15th January 2021

Information Note: Crazy Frog Type Rides

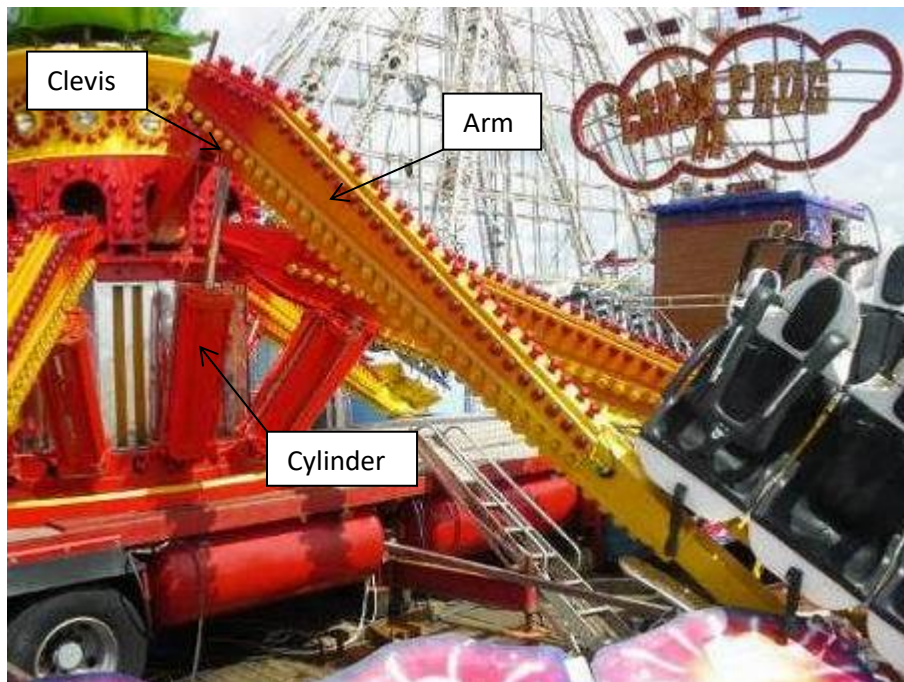
In a recent incident a pneumatic cylinder failed at the connection (clevis) between the cylinder and the central hub, causing the car and its occupant to drop to the ground whilst in motion. The threadform at the threaded end of the rod had worn to the point where it no longer positively engaged in the clevis. Examination of the ride revealed another ram where although wear was not as advanced, the threaded rod was not secure in the clevis, was free to rotate, and could be unwound by hand. The ride's cylinders did not have any practical means of tightening the threaded connection to the recommended tightening torque, nor any secondary means of restraint of the threaded connection such as a lock nut.

The worn condition of the failed component meant that the underlying cause of the failure could not be ascertained with any certainty, but it appeared that either:

- Play in components, as a consequence of inadequate tightening, subsequent loosening or both, lead to fretting wear and failure; or
- The threadform deteriorated through an end of life process such as fatigue.

Metallurgical analysis did not identify one clear underlying cause and could not rule out that a possible cause of the defect could be related to an end of life condition.

- a) A visual inspection is undertaken to identify, if there are any secondary mechanical methods of locking the clevis to the rod (e.g. a locknut) between the pneumatic cylinder and clevis.

- If there are no locking methods apparent the ride should be taken out of use, and the ride owner should seek advice from the ride inspection bodies competent person.

- If secondary locking methods are used, seek advice from the inspection bodies competent person regarding recommended tightening torque and consider using visual tell-tale indication.

- b) At annual inspection check the condition of the connection between the cylinder rod end and clevis, with particular attention given to check the condition of the threadform.

- c) Attention should also be paid to any pre-existing looseness, wear/condition of the threadforms, play in the two engaged components and the use of appropriate non-destructive testing techniques.

- d) They determine an appropriate tightening torque for reassembly, including a method for achieving and measuring tightening torque.
- e) They consider the risk of loosening and appropriate mitigation. Some designs may already have lock-nut arrangements, where this is not the case additional security must be fitted giving due consideration to what is practicable and may range from tell-tales, retrofitting locknuts, wiring, and other fastening security measures.

- g) They monitor the condition of the connection at subsequent annual inspection.
- h) The identification of play, wear or movement in the connection results in the replacement of rod and clevis components were appropriate.
